The following changes in the tender documents are effective immediately. This addendum will form part of the contract documents.

Project title/Titre du projet  
**MATSQUI COMPLEX**  
**33344 KING ROAD**  
**ABBOTSFORD, B.C.**

**INTERNAL LIGHTING UPGRADE TO LED**

Drawing title/Titre du dessin  
**PACIFIC INSTITUTION  
SITE PLAN**

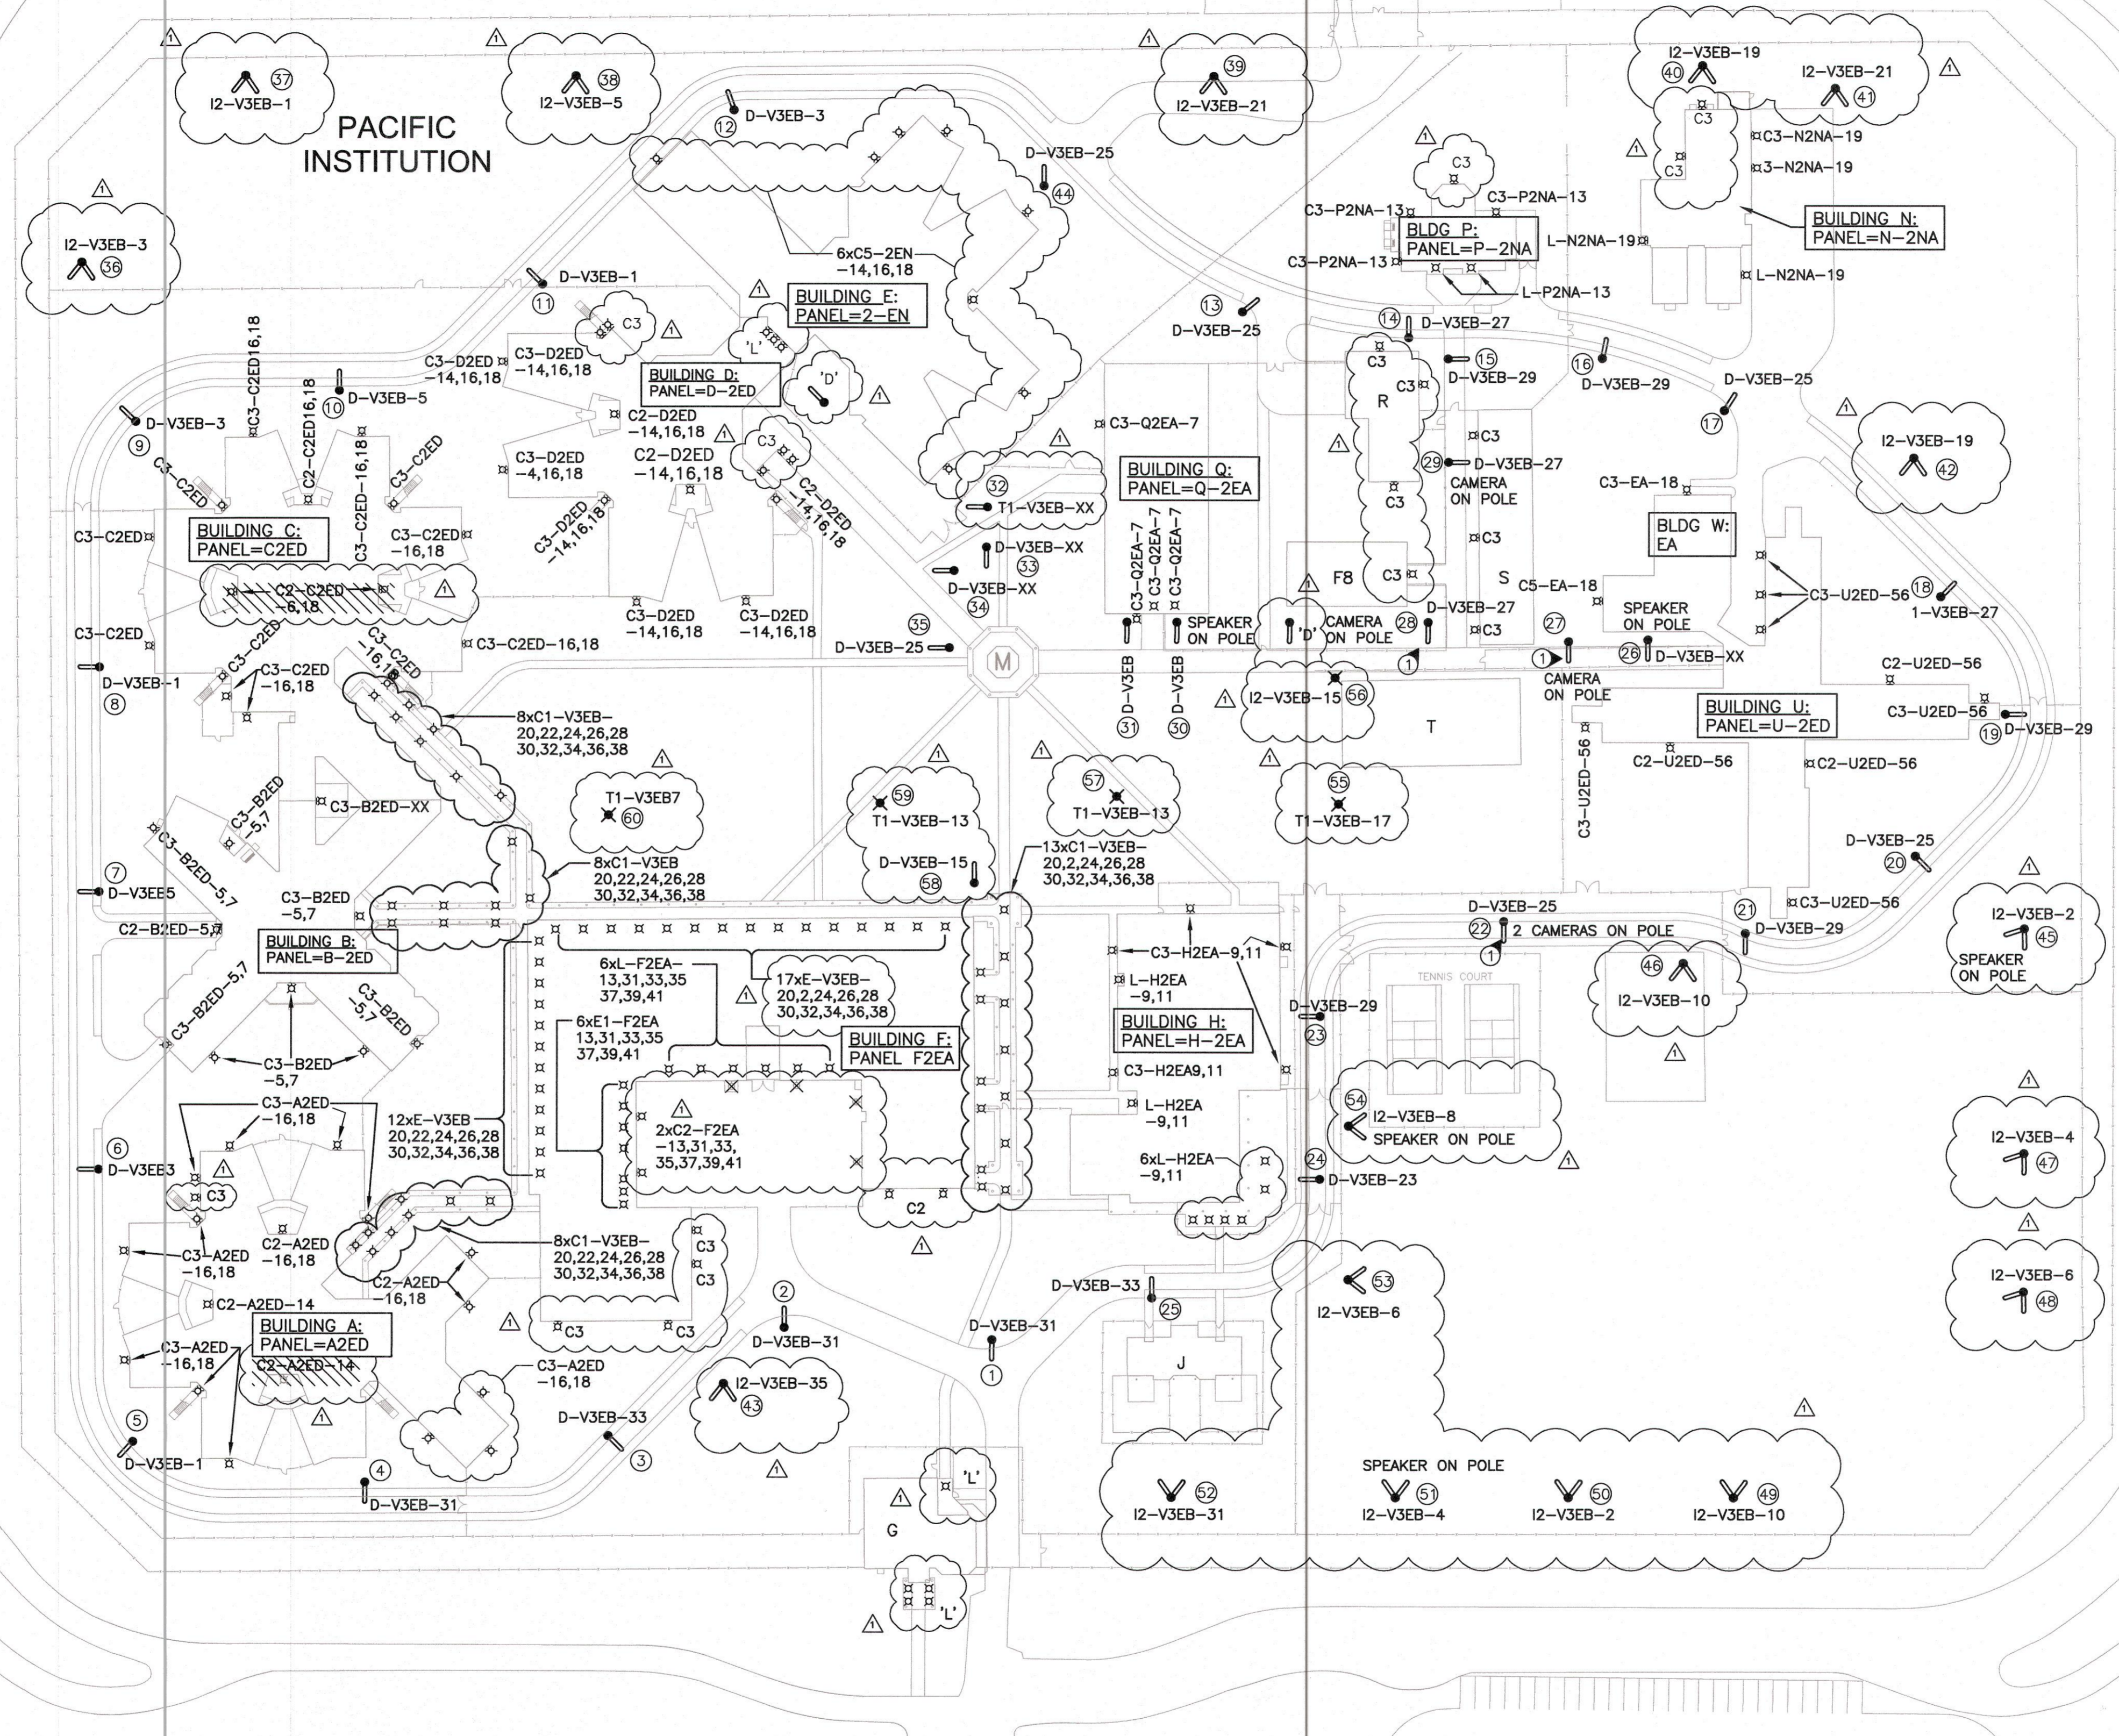
- (82) **Change:** Luminaire types 'I' on the following poles # 36; 37; 38; 39; 40; 41; 42; 43; 45; 46; 47; 48; 49; 50; 51; 52; 53; 54; 56; 58 to read **"Type 'I2'".**

- (83) **Change:** Luminaire type on poles # 18 and 58 to read; **Type 'D'**
- (84) **Change:** Luminaire type on poles # 32; 55; 57; 59; 60 to read; **Type 'T1'**

- (85) **Change:** Luminaire type on pole # 56; **Type 'I2'**
- (86) **Delete:** Type 'C2' luminaires at the Building C (total of 2).
- (87) **Delete:** Type 'C2' luminaires at the Building A (total of 1).

- (88) **Delete:** Type 'C2' luminaires at the Building F (total of 2).
- (89) **Add:** Type 'C3' luminaires at the Building F (total of 4).
- (90) **Add:** Type 'L' luminaires at the Principal Entrance Building (total of 5).

- (91) **Add:** Type 'C3' luminaires at the Building D (total of 5).
- (92) **Add:** Type 'D' luminaire near the Building D (total of 1).
- (93) **Add:** Type 'L' luminaires at the Building E (total of 3).
-

- (94) **Add:** Type 'C3' luminaires at the Building Q (total of 2).
- (95) **Add:** Type 'D' luminaire in front of Building F8 (total of 1).
- (96) **Add:** Type 'C3' luminaire at the Building F8 (total of 1).
- (97) **Add:** Type 'C3' luminaires at the Building R (total of 3).
- (98) **Add:** Type 'C3' luminaire at the Building P (total of 1).
- (99) **Add:** Type 'C3' luminaires at the Building N (total of 2).
- (100) **Add:** Type 'E' luminaires at the covered walkway near Building F (total of 2).
